## Stage 06: Draft CUSC Modification Report

# CMP237

## 'Response Energy Payment for Low Fuel Cost Generation'

CMP237 seeks to take into account the different costs of generators with low or zero energy costs through the calculation of the Response Energy Payment.

**Figure 1 - Wind holding price for Primary frequency response**

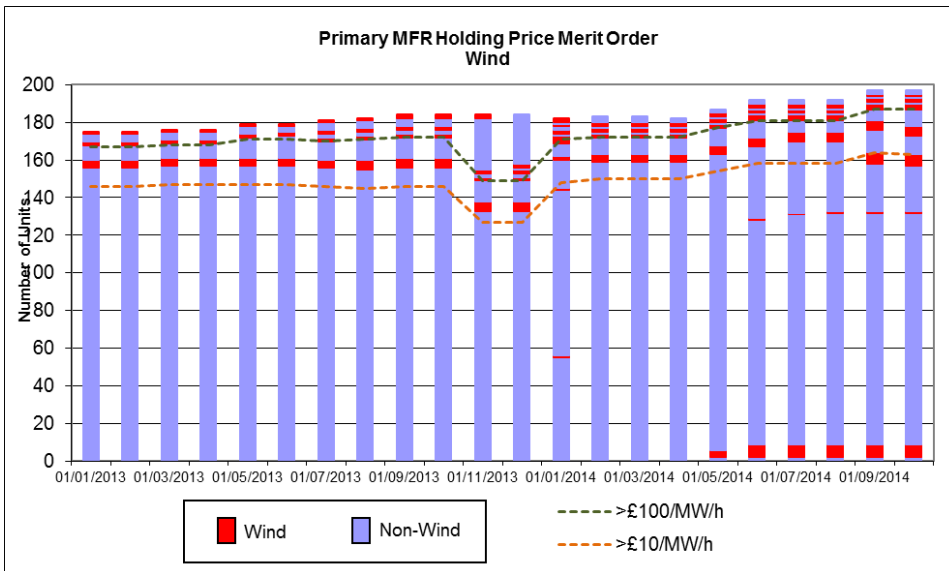
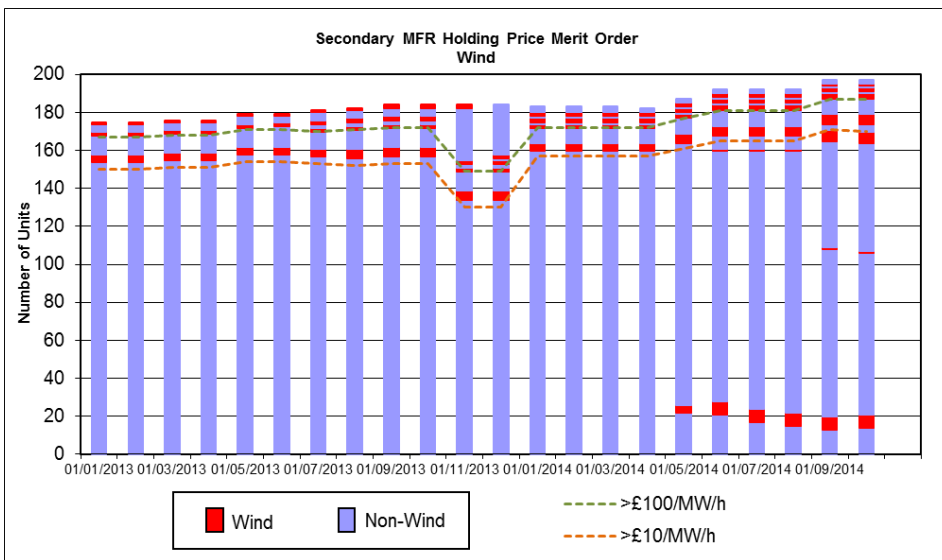
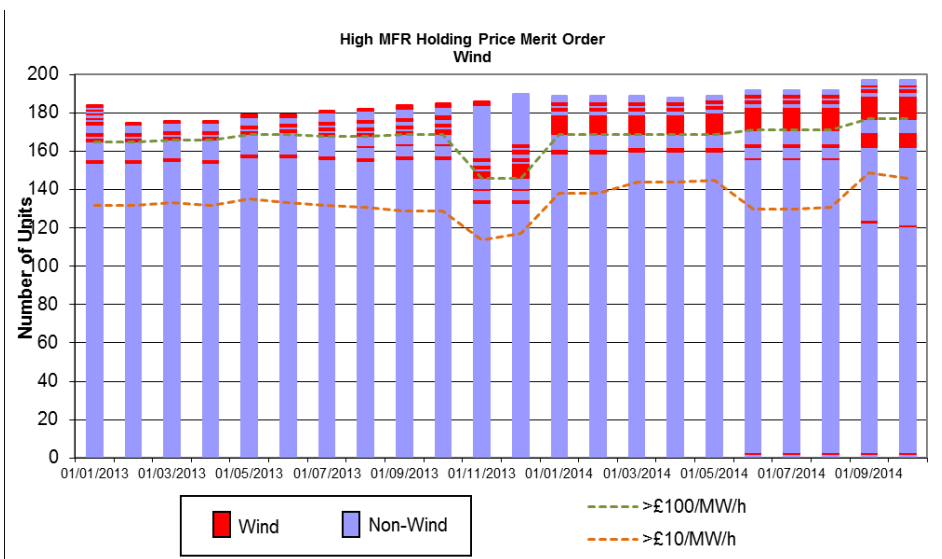
- 4.11 One Workgroup member noted that on all three graphs presented, there is an anomaly in winter 2013 where a larger proportion of plant submitted prices higher than £100/MWh and asked if there was any reason for this. The Proposer noted that after investigation, no clear reason could be found for the behaviour as the plants involved were CCGT and coal from several different companies in different parts of the country. This is the first year that the behaviour has been exhibited, and therefore it is suspected that the values may have been default inputs into the FRPS system.

**Figure 4 - submitted holding prices per generator against the estimated BM cost to move the generator to the assumed most responsive point for the 30<sup>th</sup> September 2014**

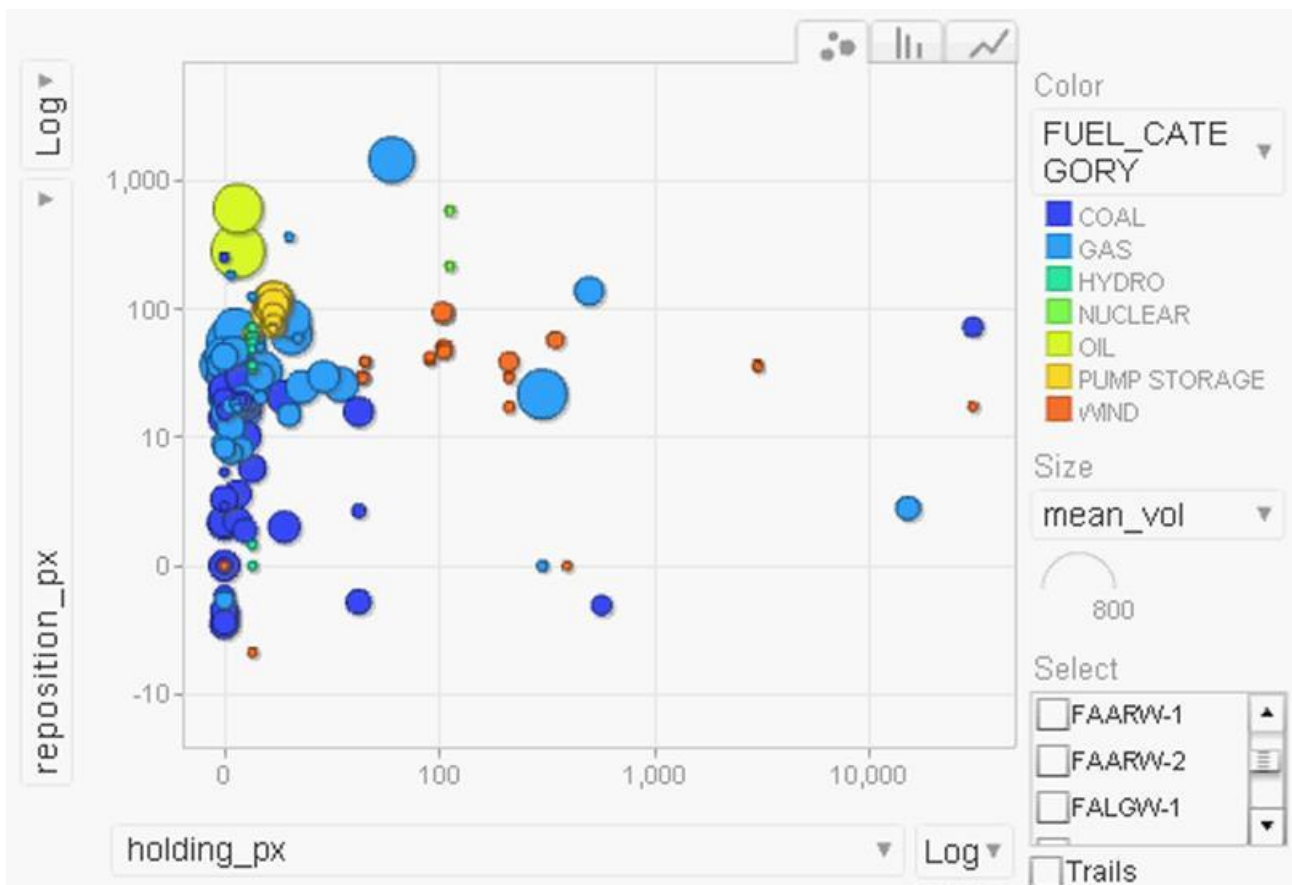
- 4.15 One Workgroup member noted that on fig 4 above, the general trend for generation with a fuel cost tended to follow the Y axis, whereas those without a fuel cost tended to follow the X axis. The Workgroup member stated that as hydro generation clearly following the Y axis like other conventional plant, this supported the view that they should be considered as having a fuel cost for the purpose of this Modification. It was noted, however, that there may be other reasons why a group of generators had similar holding prices; e.g. plant with similar construction may have similar sunk costs to recover, and that this was not direct evidence of the existence of a short-term fuel cost.

The competitive situation is most starkly shown in Figure 4 of the consultation document. This shows that hydro generation competes with other mandatory frequency response service providers (which are classified (artificially) for the purposes of CMP237 Original as ‘fuel cost’ such as coal, gas, nuclear, pump storage and oil) via the holding payment and REP. Figure 4 shows hydro generation clustering with the ‘fuel cost’ generation along the vertical. In stark contrast to this, wind generation can clearly be seen along the horizontal and no clustering pattern with ‘fuel cost’ generation can be easily discerned.
